# Access Compliance Report Public Rights-of-Way (Curb Ramps)

Main Street: ANDAZA\_ST Cross Street: ANDAZA\_ST Location: NW

ADA ID: RPRK211129135403 Ramp Type: Type 1 - Perpendicular Initial Pass/Fail: Pass Overall Compliance: No Severity Score: 35

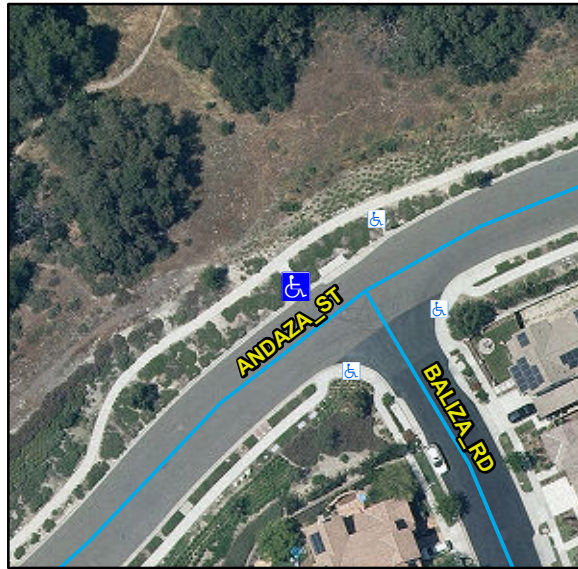
| Compliance | Description                           | Data | Compliance | Description                   | Data   |
|------------|---------------------------------------|------|------------|-------------------------------|--------|
| No         | Ramp Cross Slope (%)                  | 7.8  | N/A        | Flare Traversable LT          | No     |
| No         | Landing Run Slope (%)                 | 5.2  | N/A        | Flare Traversable RT          | No     |
| No         | Landing Cross Slope (%)               | 10.6 | Yes        | DWS Provided                  | Yes    |
| No         | Gutter Cross Slope (%)                | 8.5  |            |                               |        |

Remove & Replace Entire Ramp. Remove & Replace Gutter.
